Herschel/Planck Project

reference	SCI-PT/ 10006	page	1/4
meeting date	9-10-2001	meeting place	ESTEC
chairman	S. Thuirey		
copy participants	+ DATAMWG + J.M.C., A.E., J.B.		
subject	8th Data Management WG Meeting

Data Management WG, Meeting 8

1553 Bus Protocols

Figure 4-1: Bus message transmission in Burst Mode (PS-ICD)

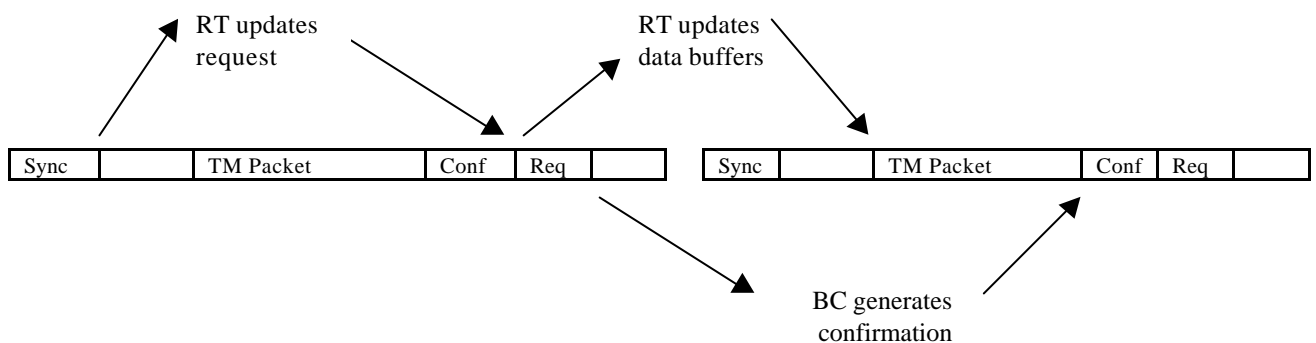
Figure 4-1 illustrates PS-ICD requirement 4700-TFL-T, specifying burst mode transfers. An RT recognises a subframe containing its packet transfer from the subframe sync message. It updates its TMReq at this point. It may update the TM Packet buffers at the same time; a maximum of 2mS is allowed from start of subframe. Alternatively, if this suits the RT software, it may prepare a new packet after the confirmation in the previous subframe as illustrated in the figure.

The BC, on reading the TMReq message, generates a TM confirmation message which will be run in the next subframe. At run-time there will not be enough time to evaluate the packet transfer for errors before the confirmation message is actually transferred. Hence the TM Confirmation merely indicates the expected transfer.

Since the bus transactions are regular and deterministic, the RT already knows that if a packet is ready it will be transferred in that subframe where the sync message contains its RT number. Thus the TM confirmation is redundant in a practical system.

Figure 4-2: Modified Packet transfer protocol

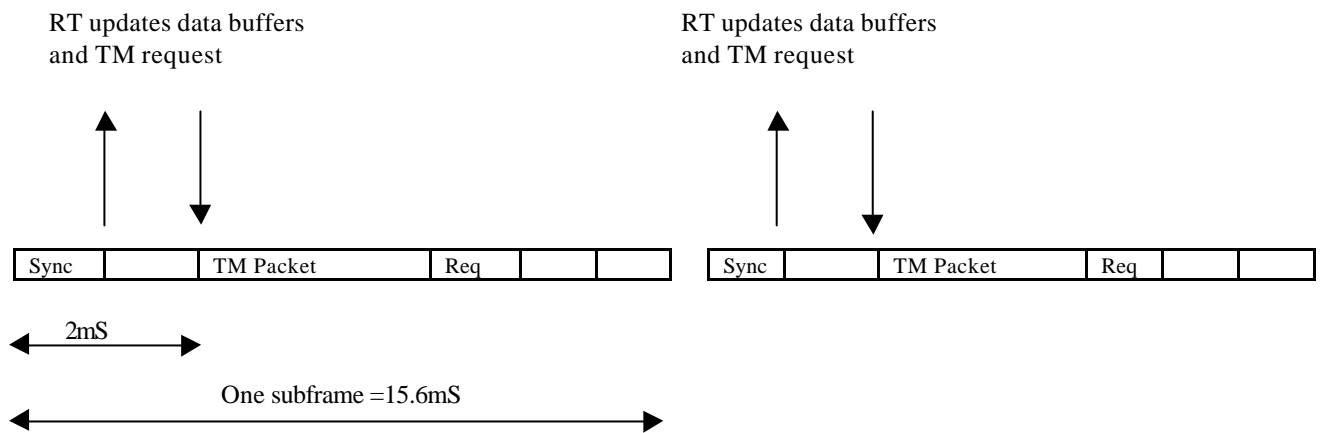
It does not make sense to have two different handshaking protocols. If burst mode is being used at all, we may as well always use the burst mode handshake. However the timing requirements are more stringent.

As mentioned in the previous section it is likely that in a practically constructed system, the TM Confirmation message will not be as useful as implied in the PS-ICD, at least in burst mode. The message is redundant if the RT uses the information in the subframe sync, and is fast enough to update its buffers in 2mS. Hence we could propose to delete it altogether.

The modified 'handshake' uses the TM Request as defined in the PS-ICD. It is polled in the same subframe as its associated Packet TM and the BC uses the information to build a packet from the data in subaddresses 11-26. The BC will always transfer all of these subaddresses from the RT. This system has the advantage that all of the messages related to one packet are in one subframe, making it much easier to construct a complete bus polling sequence for the whole spacecraft. There is also consistency between normal and burst mode requirements.
